Amendments to the Drawings

REMARKS

This Amendment is responsive to the Office Action mailed on July 13, 2006. Claims 1-21 are cancelled. New claims 22-24 are added.

Fig. 1
(PRIOR ART)

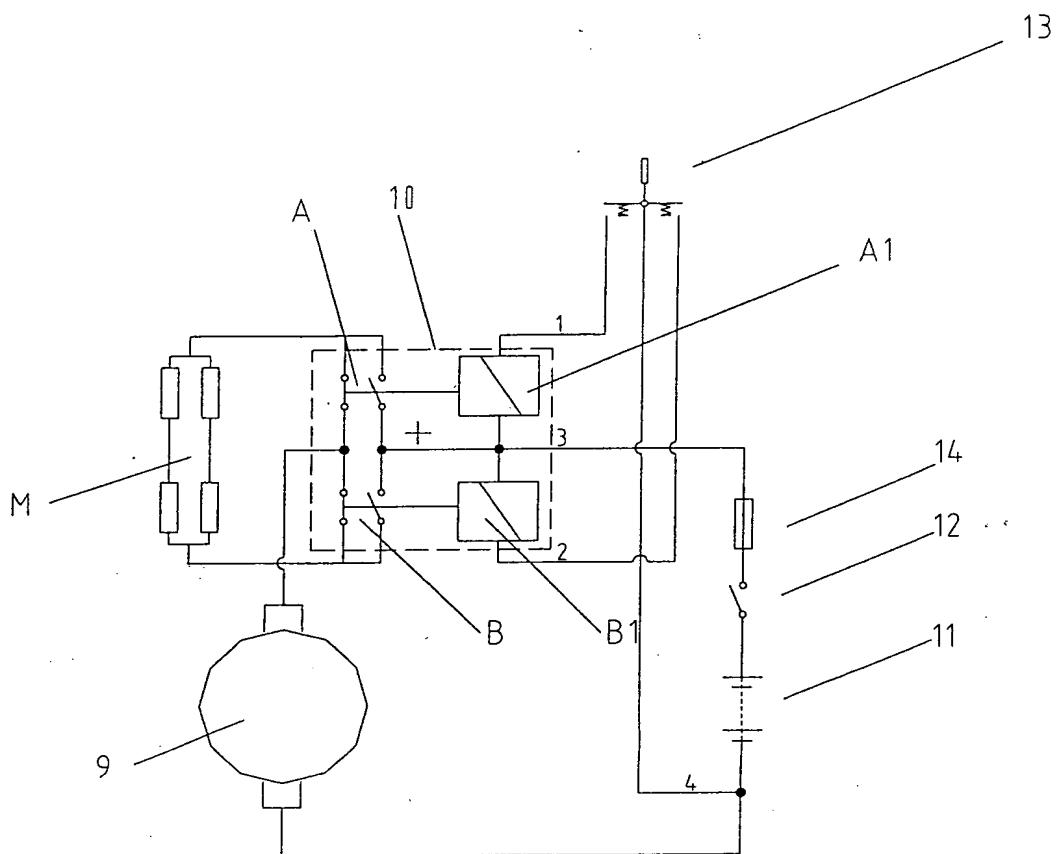
The Examiner has objected to the drawings, indicating that Figure 1 should include the legend --PRIOR ART--. Applicant submits herewith a replacement drawing for Figure 1, which now includes the legend --PRIOR ART--. Withdrawal of the objections to the drawings is respectfully requested.

The attached drawing sheet includes changes to Figure 1. The attached sheet, which includes Figure 1, replaces the original drawing sheet for Figure 1. In Figure 1, the legend "PRIOR ART" is added in order to overcome the Examiner's objection to the drawings.
